RECOMMENDED ADDITIONS/CHANGES TO SPECIFICATIONS FOR FUTURE SWIFT DESIGN

PREPARED BY HRSD EEM STAFF

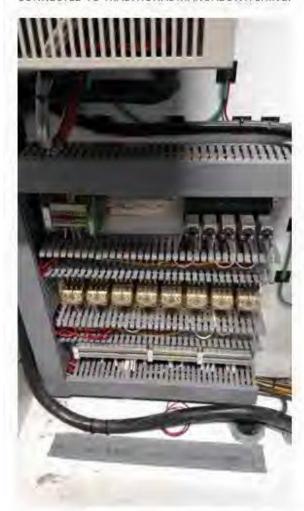
B. ALL OUTLET BOX ROUGH-INS OF GWB CONSTRUCTION SHALL USE A BRACKET TO MOUNT TO AT LEAST TWO WALL STUDS. SCREW EAR BOXES ARE NOT ACCEPTABLE. USE OF THESE BRACKETS WILL ALSO INSURE THAT BOXES MOUNTED NEXT TO EACH OTHER WILL BE LEVEL.
